Te Tai o Poutini Plan Submission

D Ellerm
136 Cashmere Bay Road
Tekimoka.

Submission in support of and requests to amend the following in the TTPP

Changes to Outstanding Natural Landscapes – Environmental and Cultural Values Map 65

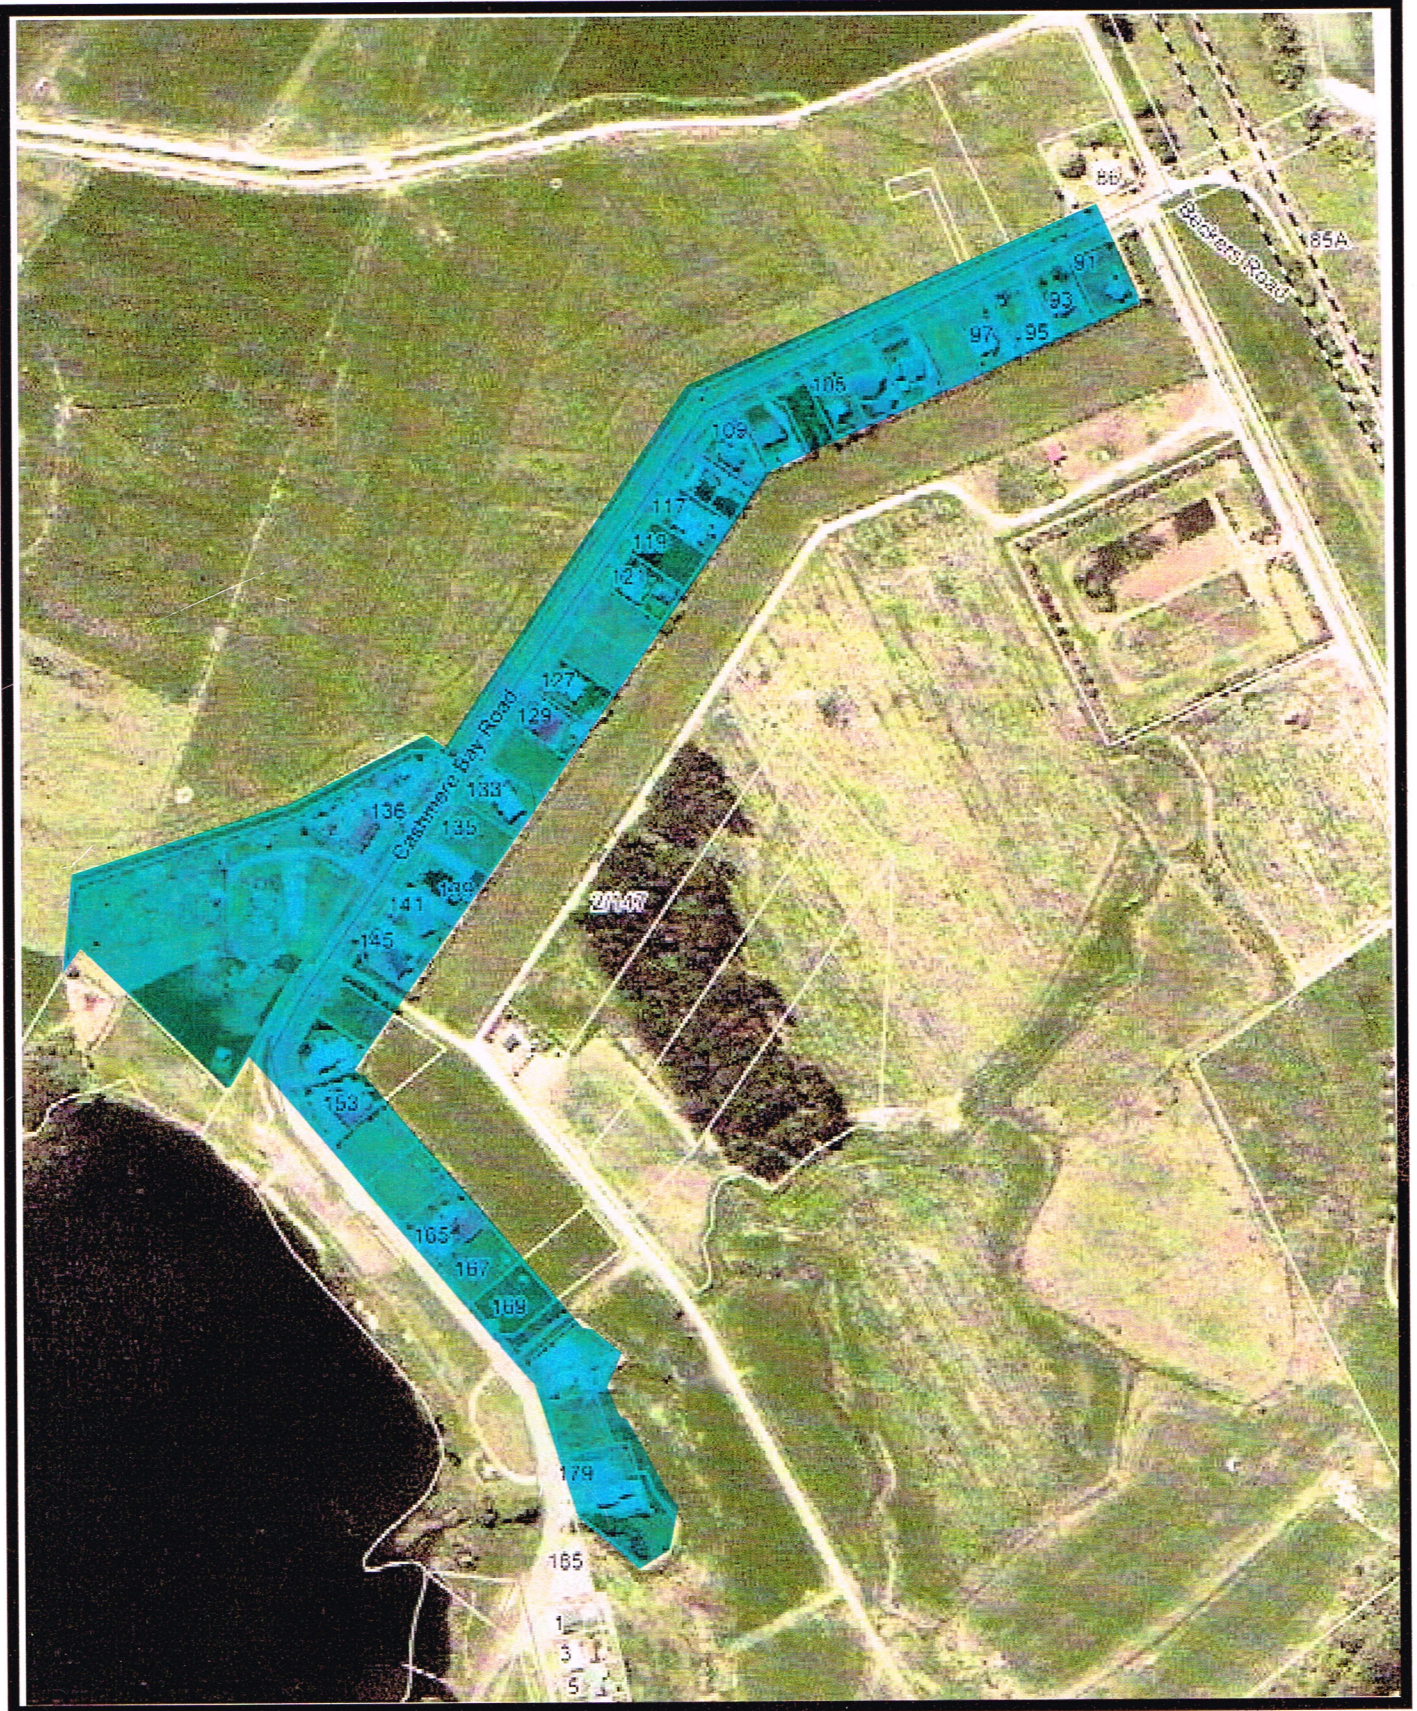
To redraw the boundary of the Outstanding Landscape Maps as described in Schedule Five; the Iveagh Bay Ngāi Tahu Development boundary as per attached map Changes to Outstanding Natural Landscapes Map 65.

Changes to the Flood Plain – Natural Hazard Map 59

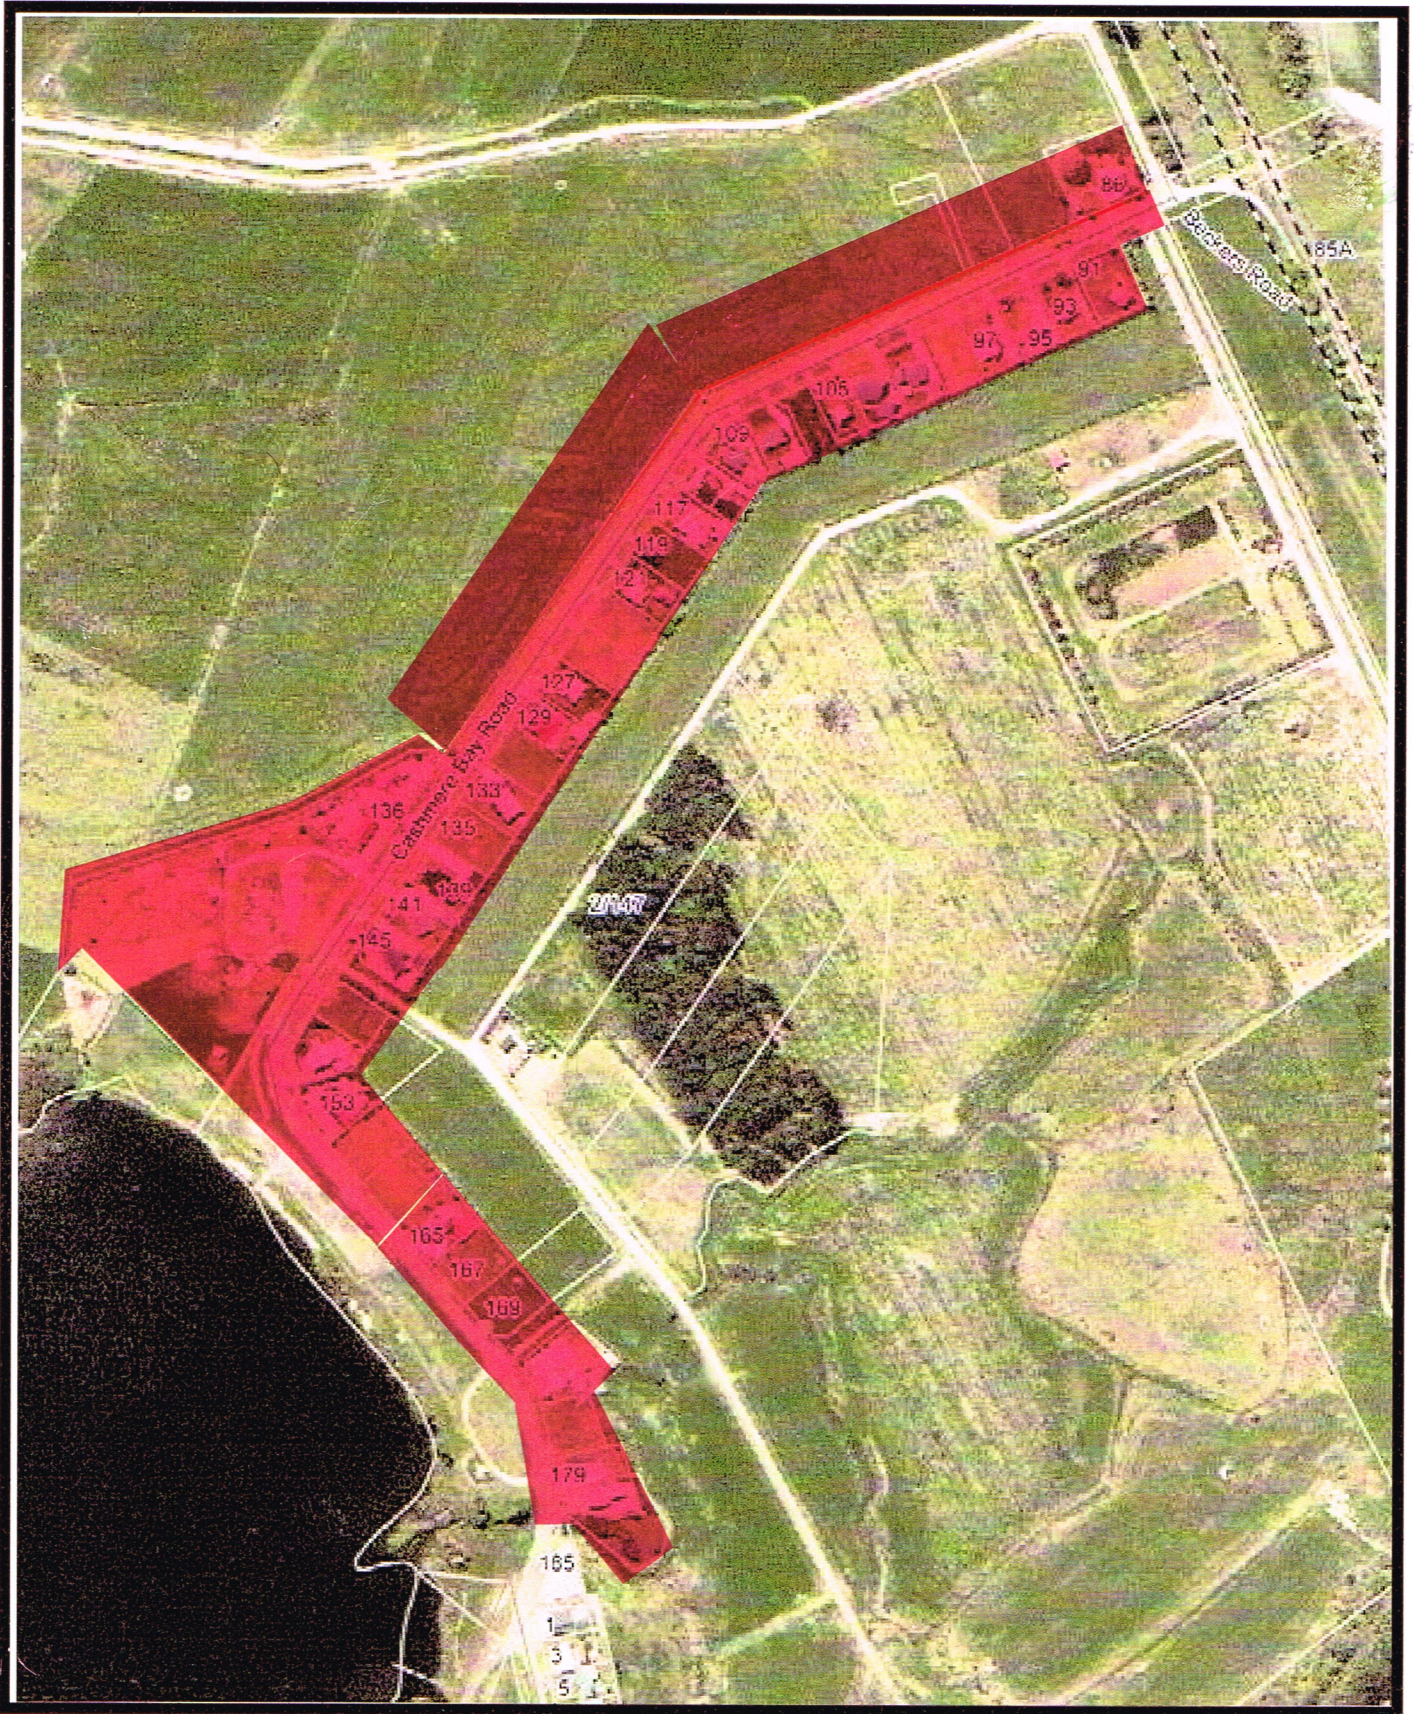
Based on my personal knowledge of the Lake Brunner river catchment, I request that the settlement area of Te Kinga is removed from the Flood Plain overlay (see attached map). There is no history of any flooding of the Te Kinga residential settlement. Any future risks of flooding by the Crooked River are mitigated by the protection provided from the railway embankment which is maintained by NZ Rail.

Remove Cashmere Bay Road residential Lots 1-28 and adjoining sites Lot 3 & 4 DP 3957 as identified on the attached plan Changes to the Flood Plain – Natural Hazard Map 59.

Character Area – Te Kinga Cashmere Bay Road Map 59

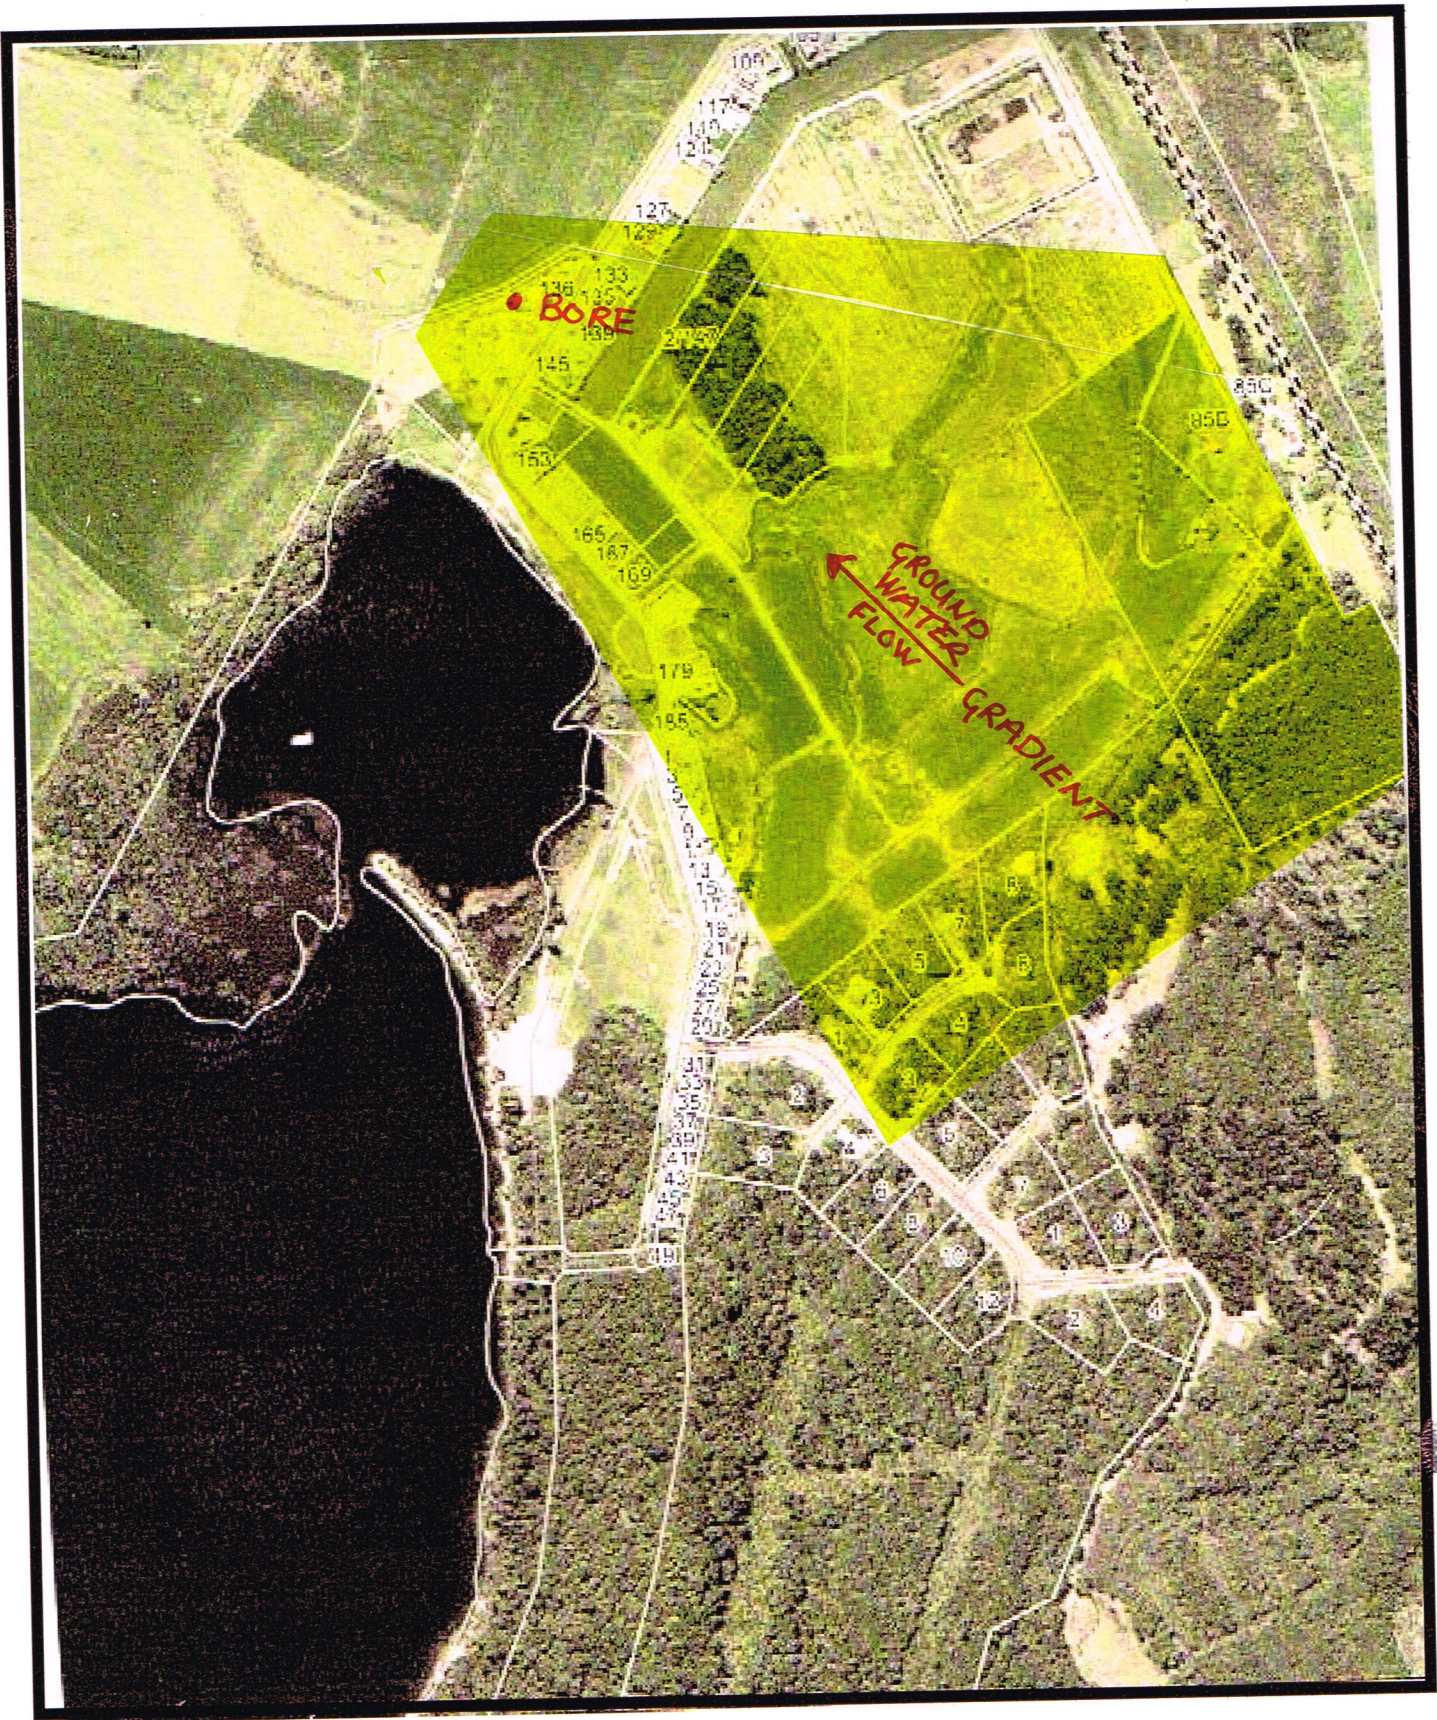
The Character Area standard applies to the following settlements;

- i. Te Kinga – Cashmere Bay Road.

See attached map Character Area Te Kinga Cashmere Bay Road Map 59.
